**16/04270/FUL (CT.0807/1/B)**

**Carted Barn  
High Street  
South Cerney  
Cirencester  
Gloucestershire  
GL7 5UG**

**The installation of new AC condensers, refrigeration plant, louvre and satellite dish at Carted Barn High Street South Cerney Gloucestershire**

<b>Full Application 16/04270/FUL (CT.0807/1/B)</b>	
<b>Applicant:</b>	The Co-operative Group
<b>Agent:</b>	Wellsfield Associates
<b>Case Officer:</b>	Andrew Moody
<b>Ward Member(s):</b>	Councillor Juliet Layton
<b>Committee Date:</b>	11th January 2017
<b>RECOMMENDATION:</b>	<b>REFUSE</b>

**Drawing Title:** REFRIGERATION / AIR CONDITIONING PLANT LAYOUT

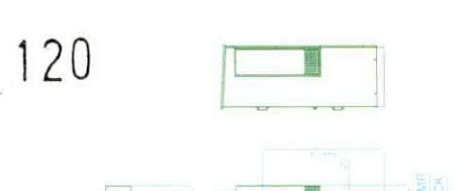
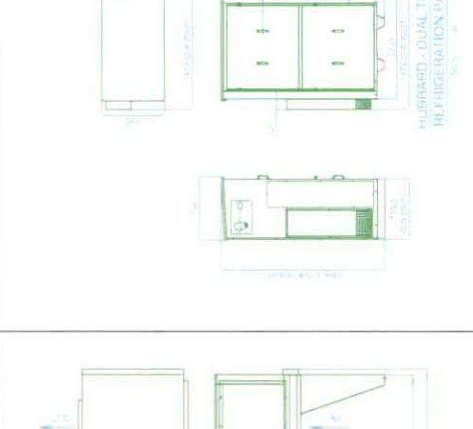
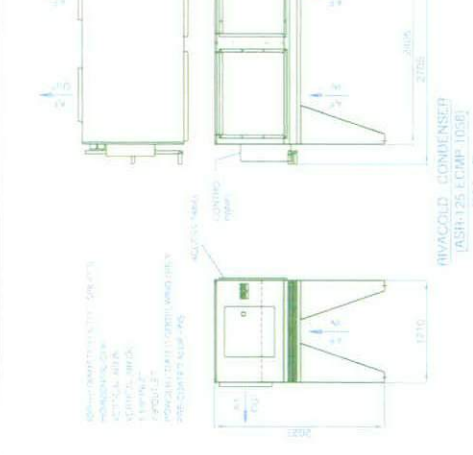
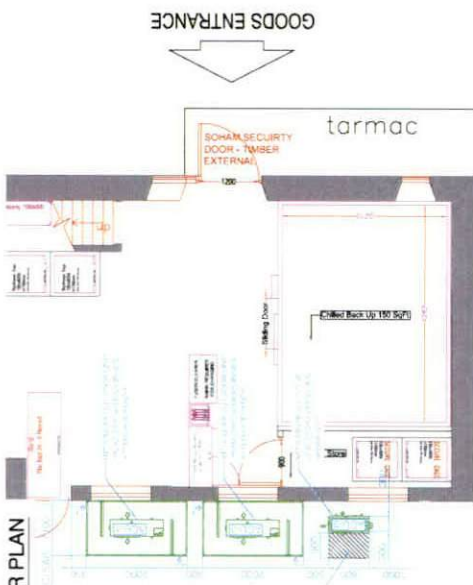
Objections have also been received with regard to the impact of the apparatus upon the amenities of local residents, specifically from noise. The original report submitted in support of the

application was not considered to be sufficient by the Environmental and Regulatory Services Officer (ERS), such that further information was requested.

This was received in the form of an amended Environmental Noise Impact Assessment Report. Attenuation measures are proposed, for example the A/C units would be contained within an acoustic enclosure that reduces atmospheric noise emissions by 20 dBA, with further attenuation fitted to the louvres. As a consequence, the Report states that the cumulative noise emissions at the nearest noise sensitive window would be 35 dBA between the hours of 0700 - 2300 hours, and 24 dBA between 2300 and 0700 hours.

Following consultation with ERS, it has been commented that 'the inclusion of additional calculation data demonstrates how the target noise levels will be achieved. Target levels are appropriate for the protection of amenity of nearby residents.' A condition is recommended to limit noise emissions to 38 dBA between 0700 - 2300 hours, and 28 dBA between 2300 - 0700 hours, although the actual levels anticipated by the Report would be lower than this.

Noise emitted from the site as a result of mechanical plant shall not exceed 38dB LAeq1 hour between 0700 hours and 2300 hours; and 28dB LAeq1hour at any other time, as measured at the façade of any residential property.

Site Plan showing proposed external A/C locations on Ground Floor (Courtesy of Wellsfield Associates © 2015)

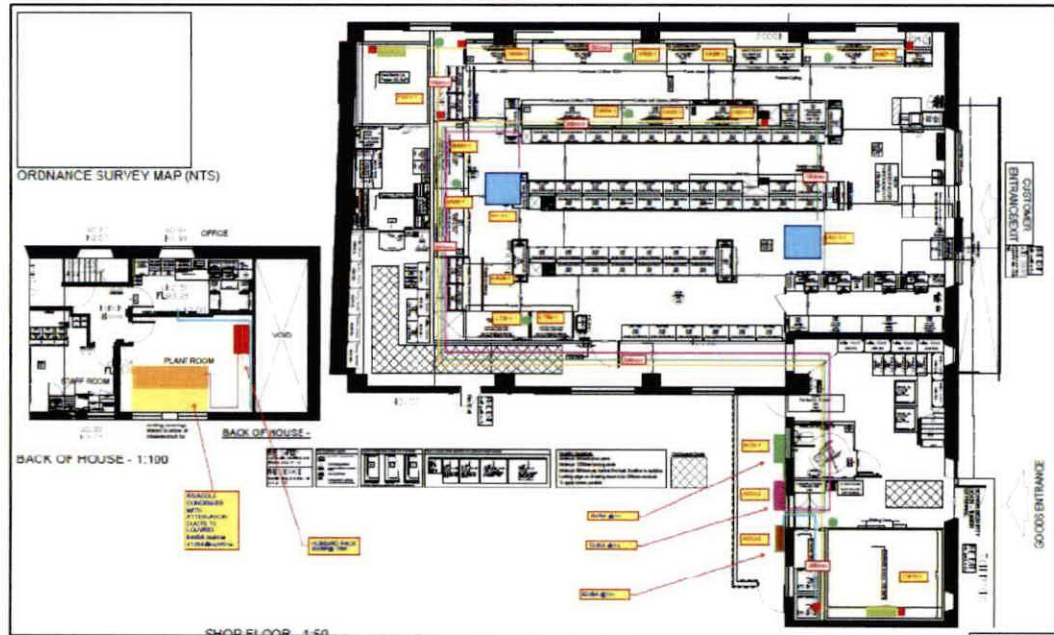
The AC condensers, refrigeration plant and louvre would be sited to a rear facing elevation of the building, whilst the satellite dish would be installed to the roof at the southern end of the building. The external apparatus would be sited within an attenuation box and screened by a 2m high timber fence enclosure, whilst the louvre would be attached to the rear facing wall.

It is not considered that the installation of the satellite dish at the southern end of the building would impact upon the setting of these designated heritage assets, and similarly the AC condensers, refrigeration plant and louvre would be located to the rear facing wall of the building, and not therefore be visible from within the conservation area.
